APPLICATION NO.	FILING DATE	FIRST NAMED INVENTOR	ATTORNEY DOCKET NO.	CONFIRMATION NO.
10/628,718	07/28/2003	Helmut Kadmoska	WBW-12002	6749

Office Action Summary

DETAILED ACTION

2,277,738

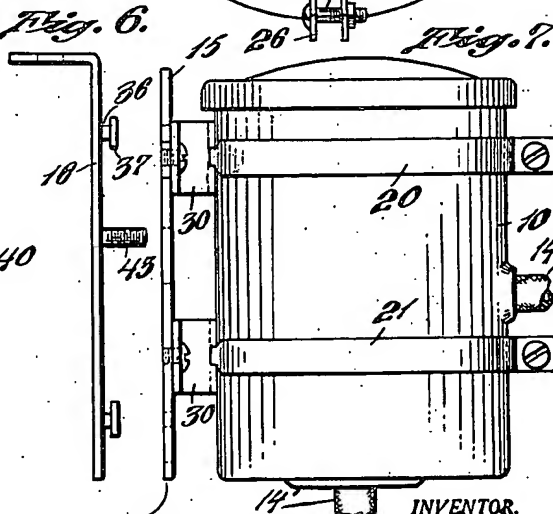
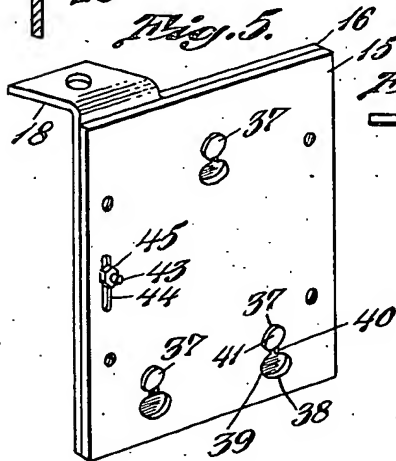
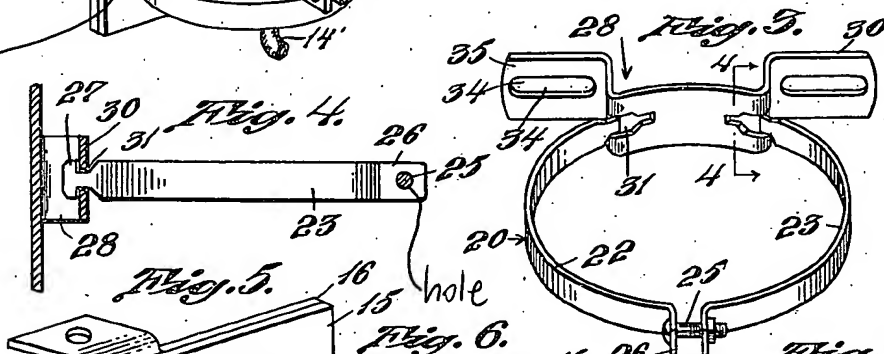
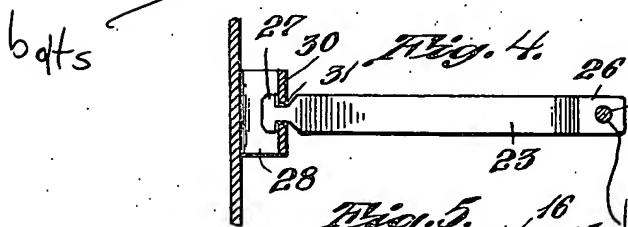
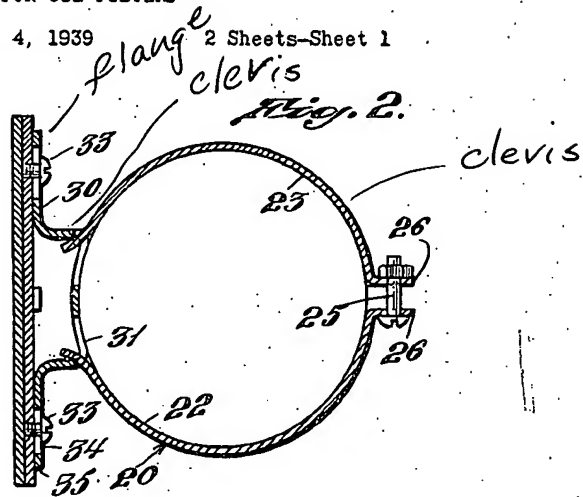
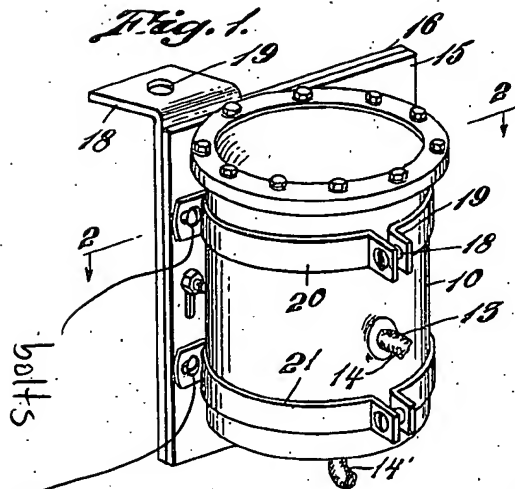
Claims 1-10 are rejected under 35 U.S.C. 103(a) as being unpatentable over Wilkinson (2,277,738), in view of Byerly (4,338,707). Wilkinson teaches, substantially, each feature of the claimed invention as shown in the attached marked-up copy of Wilkinson's Figures 1-7. Wilkinson does not teach a conduit for receiving the line material or an elongated hole in a first one of the parts. Byerly however teaches a conduit/liner (30) for cushioning the contact between the cable or pipe to be supported and the support. It would have been obvious to one of ordinary skill in the art at the time of invention to have modified Wilkinson to have a lining along Wilkinson's the clevis members (22 and 23) to form a conduit as taught by Byerly in order to cushion the contact as taught by Byerly. Regarding claim 4, if Byerly's duct (30) is formed in the shape of Wilkinson's clevis members (22), its ends will be inwardly bent. It would also have been obvious to one of ordinary skill in the art at the time of invention to have modified Wilkinson's hole to be elongated to increase the flexibility of positioning as taught by Wilkinson's flange hole (34) to make insertion and positioning of Wilkinson's journal (25) easier.

Claims 15-19 are rejected under 35 U.S.C. 103(a) as being unpatentable over Wilkinson (2,277,738), in view of Byerly (4,338,707) and Taft (928,711). Wilkinson teaches, substantially, each feature of the claimed invention as shown in the attached marked-up copy of Wilkinson's Figures 1-7. Wilkinson does not teach a conduit for receiving the line material or an elongated hole in a first one of the parts. Byerly, however, teaches a conduit/liner (30) for cushioning the contact between the cable or pipe to be supported and the support and Taft teaches the polygonal shape. It would

FIG. 1

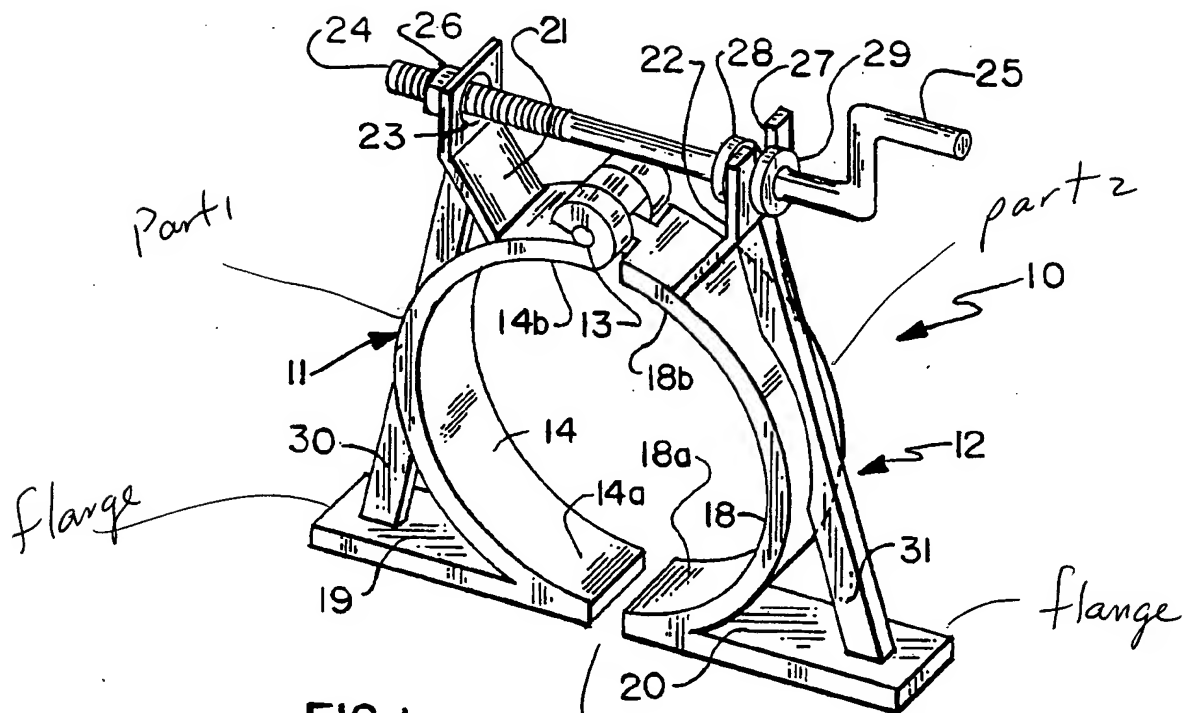
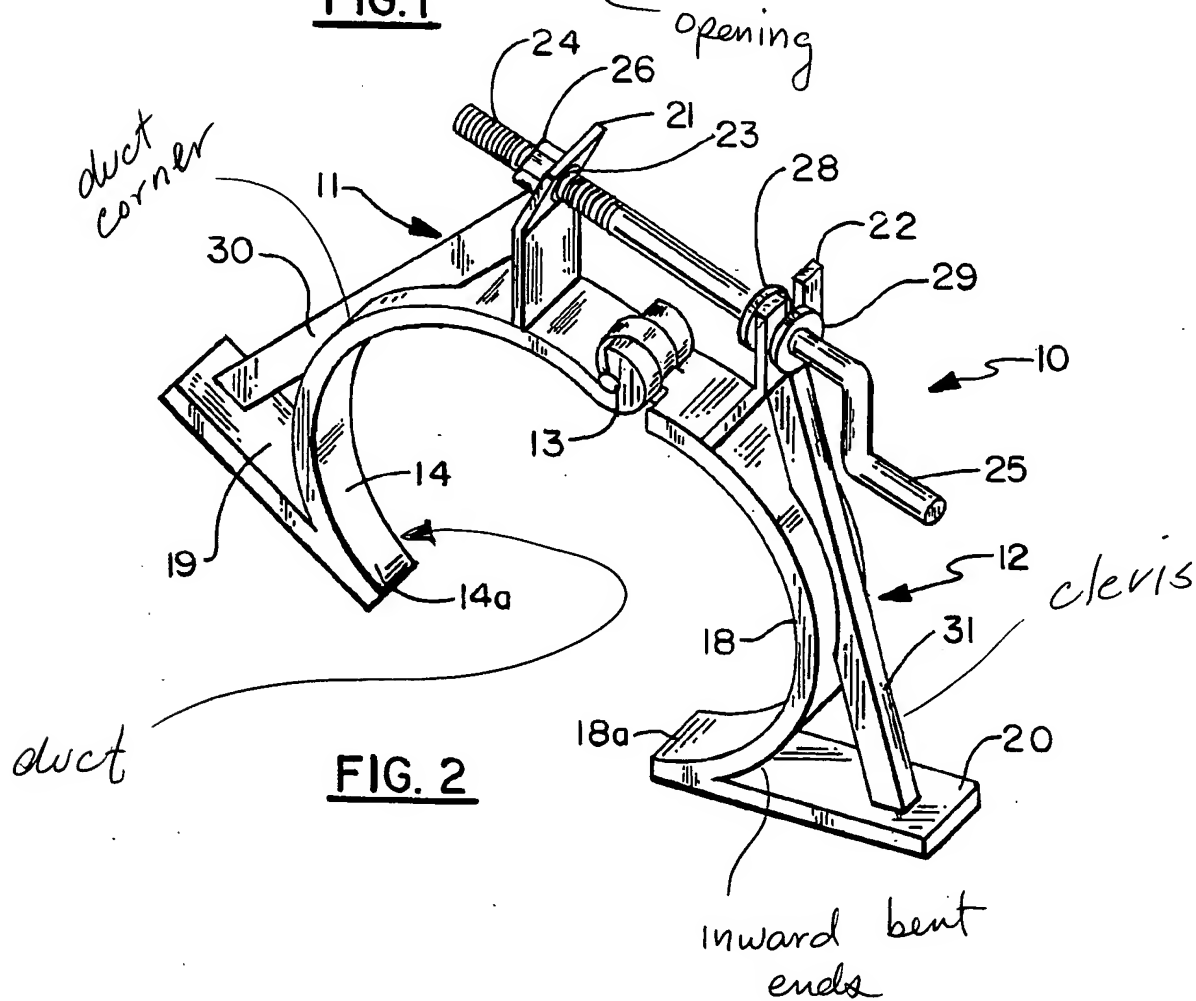
Claims 1-4 and 11-14 are rejected under 35 U.S.C. 102(b) as being anticipated by Schlenker (5,462,246). Schlenker teaches each feature of the claimed invention as shown in the attached marked-up copy of Schlenker's Figures 1 and 2. Regarding claim 12, Schlenker's duct includes (14) and (35).
